Project	IEEE 802.16 Broadband Wireless Access Working Group < http://ieee802.org/16 >	
Title	A Generic Packet Convergence Sublayer (GPCS) for Supporting Multiple Protocols over 802.16 Air Interface	
Date Submitted	2005-11-09	
Source(s)	Lei Wang, Brian Petry, Yair Bourlas, Kenneth Stanwood, Cygnus Communications Inc. Phillip Barber Huawei	Voice: 760-448-4168 Fax: 760-448-1989 lwang@cygnuscom.com ybourlas@cygnuscom.com bpetry@cygnuscom.com
Re:	This is a follow-up contribution on the proposal of a generic packet convergence sublayer.	
Abstract	<p>As requested by 802.16g during the comments resolution discussions in session #39, we are submitting a follow-up contribution on our Generic Packet Convergence Sublayer proposal i.e., C802.16g-05/25, by presenting additional supporting materials and integrating suggestions and comments received from other members.</p> <p>We are concerned that the 802.16 protocol cannot easily be extendable to transport new protocols over the 802.16 air interface. It would appear that a convergence sublayer is needed for every type of protocol transported over the 802.16 MAC. Every time a new protocol type needs to be transported over the 802.16 air interface,

Figure 17c: GPCS Layering Model

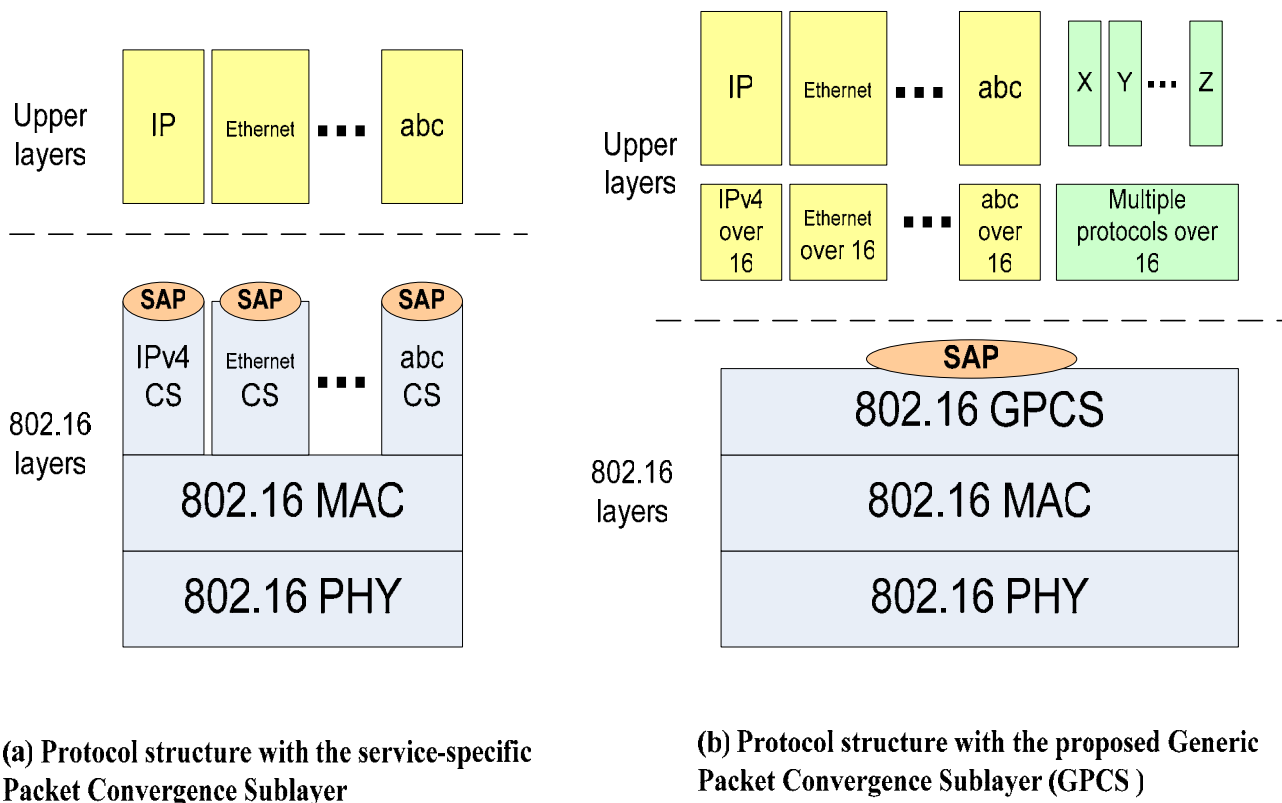
1. page 3 replace line 1 to line 52 by the following text:

5.2.8 Generic Packet Convergence Sublayer (GPCS)

The Generic Packet CS (GPCS) is a upper layer protocol-independent packet convergence sublayer that supports multiple protocols over 802.16 air interface. It is defined as follows:

- GPCS provides a generic packet convergence layer. This layer uses the MAC SAP and exposes a new SAP to GPCS applications
- GPCS does not re-define or replace other convergence sublayers. Instead, it provides a SAP that is not protocol specific

- The basic function of the GPCS is still classification. It participates in the process to map upper layer packets (carried in 802.16 MAC SDUs) to appropriate 802.16 connections. But with GPCS, packet parsing happens “above” GPCS. The results of packet parsing are classification parameters given to the GPCS SAP for “parameterized classification,” but upper layer packet parsing is left to the GPCS application

- GPCS defines a set of SAP parameters as the result of upper layer packet parsing. These are passed from upper layer to the GPCS in addition to the data packet. Each is defined in section 5.2.8.1.

- LOGICAL_LINK_ID
 - COS_ID (Class of Service ID)
 - PROTOCOL_TYPE
- GPCS provides an optional way to multiplex multiple layer protocol types (e.g., IPv4, IPv6, Ethernet) over the same 802.16 connection/service flow. A TLV parameter, MULTIPROTOCOL_ENABLE, is defined in the DSx messages to enable/disable this feature.

- For interoperability, each upper layer protocol type needs an interface specification (e.g., IPv4 over 802.16, or Ethernet over 802.16). Such a standard specification is out of scope of the GPCS.

Figure 17d: GPCS SAP Parameters Model

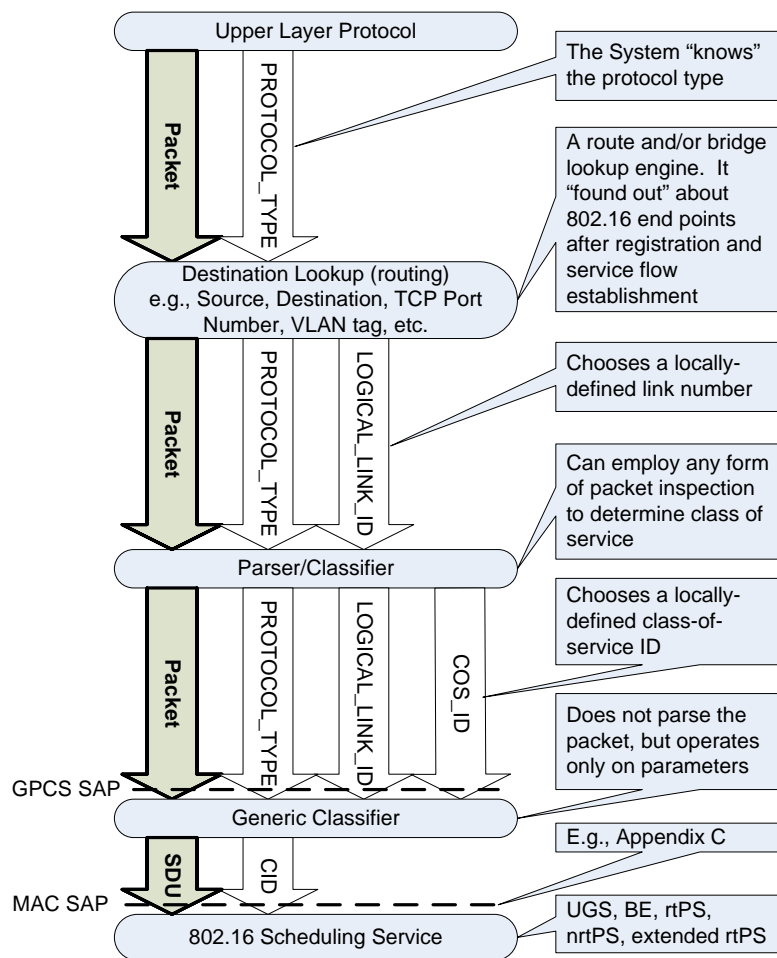
5.2.8.1 GPCS Service Access Point (SAP) Parameters

The GPCS SAP parameters enable the upper layer protocols to generically pass information to the GPCS so that the GPCS does not need to interpret upper layer protocol headers in order to mapping the upper later data packets into proper 802.16 MAC connections. Since the SAP parameters are explicit, the parsing portion of the classification process is the responsibility of the upper layer. The SAP parameters need to be specified in the standard to provide an interface point where compliance can be measured independent of the upper layer protocol type (Ethernet, IPv4, etc.).

There are four GPCS SAP parameters: LOGICAL_LINK_ID, COS_ID, PROTOCOL_TYPE, and. Figure 17d depicts the GPCS SAP parameters model. It shows how the first three GPCS parameters, LOGICAL_LINK_ID, COS_ID, and PROTOCOL_TYPE, are chosen in a system. The parameter, MULTI_PROTOCOL_ENABLE, is required for signaling whether or not the multiple protocol packets are transmitted on the same CID.

- PROTOCOL_TYPE.** The protocol type field identifies the upper layer protocol that is immediately above the 802.16 protocols. If `MULTI_PROTOCOL_ENABLE` is activated, the `PROTOCOL_TYPE` shall be also carried over-the-air in every SDU, so the 802.16 receiver can demultiplex an SDU and invoke the appropriate upper layer protocol. If `MULTIPROTOCOL_ENABLE` is not activated, an 802.16 CID can carry only one protocol type, and the `PROTOCOL_TYPE` field is only communicated during connection establishment through DSx messages. It is thus analogous to the “ethertype” field in an Ethernet packet or the 16-bit PPP data link (DL) layer protocol field in PPP packets. The GPCS can either uses the IANA to assign 2-byte 802.16 `PROTOCOL_TYPE` numbers, or maybe just borrow the number space from PPP. Note that GPCS with `MULTIPROTOCOL_ENABLE` is just about like Ethernet Packet CS except no Ethernet addresses are transported, and so they don’t need to be header-compressed.

- LOGICAL_LINK_ID.** A link number that is output from a bridging or routing function. It is locally assigned and not exchanged between 802.16 air link. For instance, an 802.1D bridge agent in a BS could discover a service flow to a specific SS and assign a `LOGICAL_LINK_ID` number to that service flow plus SS entity. The `LOGICAL_LINK_ID` can thus become a destination link for an 802.1D bridge. It could transact spanning tree and GARP messages and relay and filter packets based on 48-bit 802 MAC address and VLAN tags. The exact mechanism for how this is done is beyond the scope of the GPCS.

- **COS_ID (Class of Service ID).** A class of service identifier output from a packet-parsing classification function. The class of service could simply identify an 802.16 scheduling service type. Alternatively, a system could define it as a superset of 802.16 scheduling services, and perform local scheduling and/or queuing based on the value. So, instead of specifying COS_ID to mean exactly the 802.16 scheduling service type, it is left as an abstract locally-defined identifier. In either case, the GPCS takes the COD_ID as input and uses it to determine a CID with matching 802.16 scheduling services.

- **MULTI_PROTOCOL_ENABLE.** This parameter is not shown in Figure 17d. A local system can optionally choose to enable/disable multiple PROTOCOL_TYPES to be carried over a single CID. MULTI_PROTOCOL_ENABLE is useful for devices that are constrained to implement a small number of CIDs yet need to carry a variety of protocols using the same 802.16 scheduling service type. For instance, a single best-effort (BE) connection could carry statistically multiplexed packets of IPv6, IPv6-ROHC and Ethernet PROTOCOL_TYPES.
